# Work Order ID 88926

DESIGN 		DRAWN BY 		DART AEROSPACE LTD HAWKESBURY, ONTARIO, CANADA	
CHECKED 		APPROVED 		DRAWING NO. D3183	
DATE 04.02.17		TITLE BRACKET ASSEMBLY		REV. C SHEET 1 OF 4 SCALE 1:1	
A	03.01.24	NEW ISSUE			
B	03.06.17	REMOVE BEARING; 1.012 WS 0.882			
C	04.02.17	ADD -045/-9; 0.182 WAS 0.431			
C1	<del>04.11.09</del> 04.11.09	0.830 WAS 0.850

DRAWING NO. D3183	TITLE BRACKET ASSEMBLY	REV.C1	DART AEROSPACE LTD ENGINEERING ORDER		D.E.O. NO. D3183-C1-1	SHEET NO. SHEET 1 OF 1	SCALE NTS
DRAWN qp	CHECKED L	MFG. APPR. M	APPROVED MP		DE APPR. H		
DATE 10.05.14	DATE 10.06.30	DATE 10.06.30	DATE 10/06/30		DATE 10/06/30

#### **D3183-5 BEARING: SPECIFICATION CONTROL DRAWING**

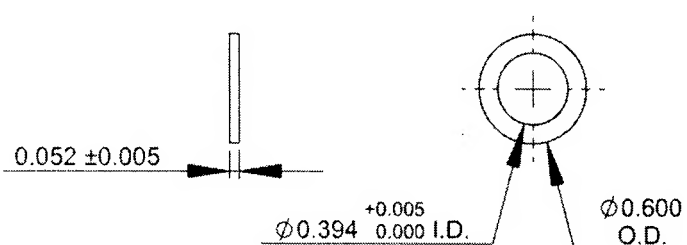
D3183-5 BEARING

ADD POSSIBLE SUPPLIER: KML P/N 6800-ZZ

BASIC LOAD RATING REQUIREMENT:      Cr = 1720 N (386 lb) MIN [DYNAMIC]  
Cor = 840 N (188 lb) MIN [STATIC]
